# Access Compliance Report

## Public Rights-of-Way

Intersection ID: 44933	Main Street: ACORN_FOREST_LN	Cross Street: BRUMIT_LN	Location: E
ADA ID: ADDB95A0219F	Ramp Type: Perp	Initial Pass/Fail: Fail	Overall Compliance: No
Severity Score: 37.5			
Codes/Mitigation Info/Possible Solution		Field Measurements/Component Compliance

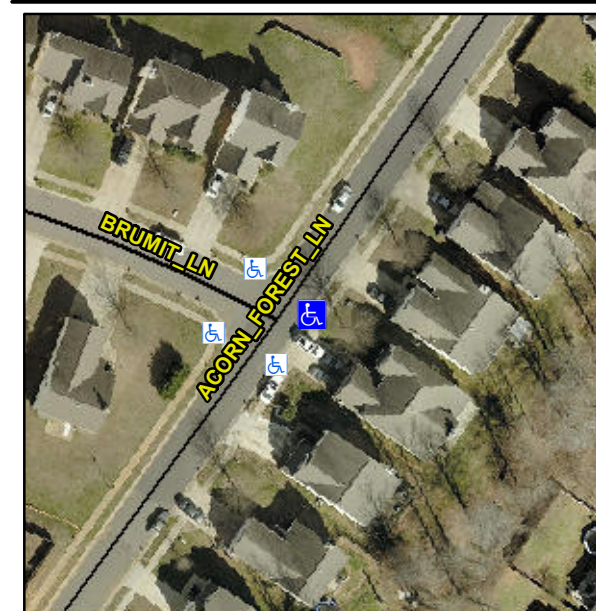
**Not Found, R304.2.2, R304.5.3**

Compliance	Description	Data	Compliance	Description	Data
N/A	Ramp Length (in)	48.0	No	Ramp Slope (%)	20.0
Yes	Ramp Width (in)	50.0	No	Ramp XSlope (%)	5.9
N/A	Flare Type LT	N/A	N/A	Flare Type RT	N/A
N/A	Flare Slope LT (%)	N/A	N/A	Flare Slope RT (%)	N/A
N/A	Flare Traversable LT?	N/A	N/A	Flare Traversable RT?	N/A
N/A	Landing Length (in)	N/A	N/A	DWS Provided?	N/A
N/A	Landing Width (in)	N/A	N/A	DWS Contrast?	N/A
N/A	Landing Slope (%)	N/A	N/A	DWS Length (in)	N/A
N/A	Landing X Slope (%)	N/A	N/A	DWS Full Width?	N/A
N/A	Landing Curb? (Y/N)	N/A	N/A	DWS Offset (in)	N/A
N/A	Shared Landing?	N/A			
N/A	Gutter Ponding?	N/A	N/A	Gutter Slope (%)	N/A
N/A	Gutter Lip Ht (in)	N/A	N/A	Gutter X Slope (%)	N/A
N/A	Painted X Walk1?	No	N/A	Painted X Walk2?	N/A
	X Walk 1 Direction	To NW		X Walk 2 Direction	N/A
N/A	X Walk 1 Width (in)	N/A	N/A	X Walk 2 Width (in)	N/A
	X Walk 1 Slope (%)	2.9		X Walk 2 Slope (%)	N/A
	X Walk 1 X Slope (%)	5.7		X Walk 2 X Slope (%)	N/A

**Remove & Replace Entire Ramp.**
